**Evaluation of Supplemental Environmental Noise
Analysis
for “Cohocton Wind Power Project”**

R.H. Bolton
January 23, 2007
Rev. 2

Fig. 5: Graph of Microphone Measurement Error Superimposed over Field Data

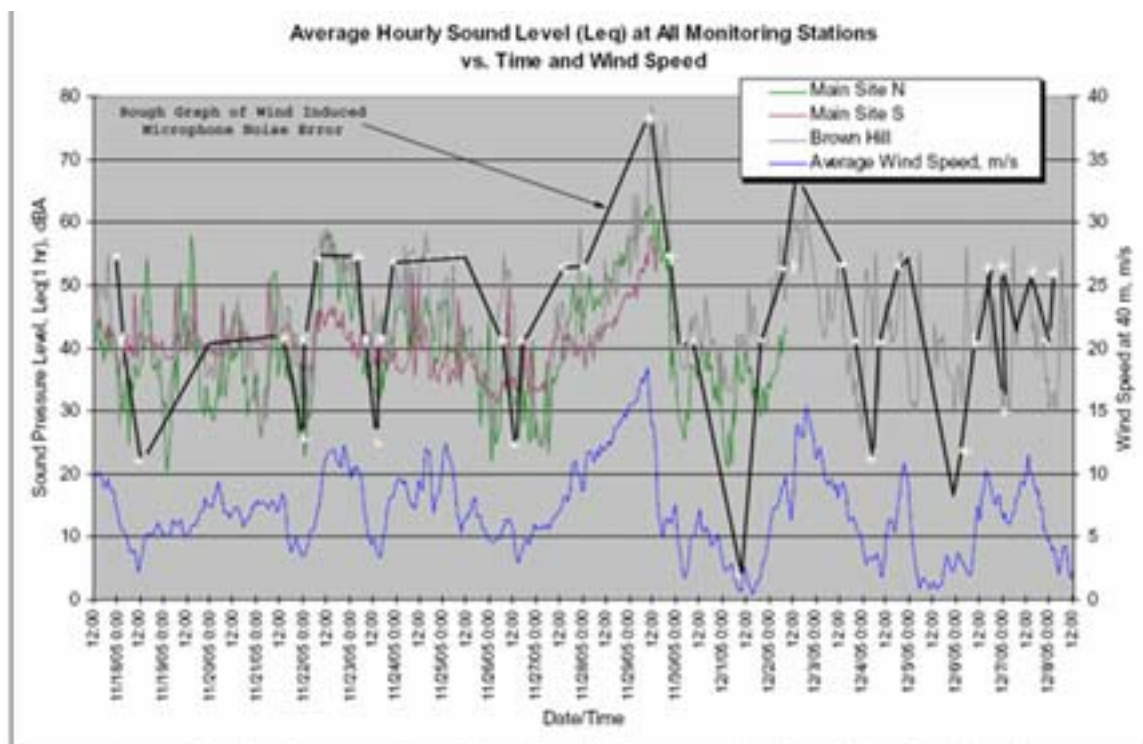
Hessler states that the “microphones were protected from rain and self-induced wind noise by waterproof double windscreens.” (Appendix I, section 2.3 “Instrumentation and Survey Duration”) but this is merely to keep rain out and reduce the error from the “no windscreen” condition in Fig. 3.

Figure 5 shows a rough plot of the microphone error (Fig. 3) superimposed over the measured noise data that Hessler provides from raw hourly data. The microphone error, which masks the true background sound levels, clearly is the only data that is recorded by Hessler’s sound instrumentation. If the errors were small enough they could be subtracted from Hessler’s graph to provide the true background. But in the situation here the error is essentially the only measurement recorded and swamps out any bona fide background level that may exist.

Fig. 9: Enlarged View of Graphic C, Hessler Predicted Noise Contours with Light Omnidirectional Wind

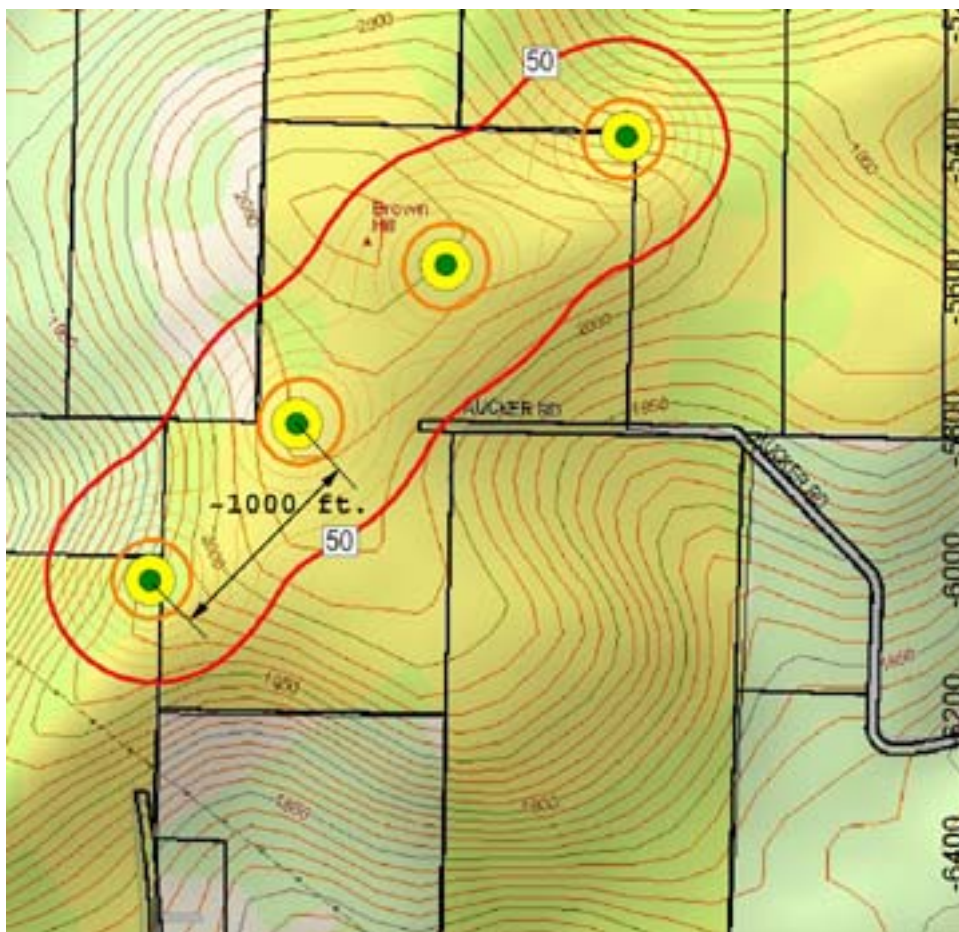
See Fig. 9 below, an enlarged section of Graphic C, which purports to show omnidirectional propagation for light winds, but obviously understates the true impact.
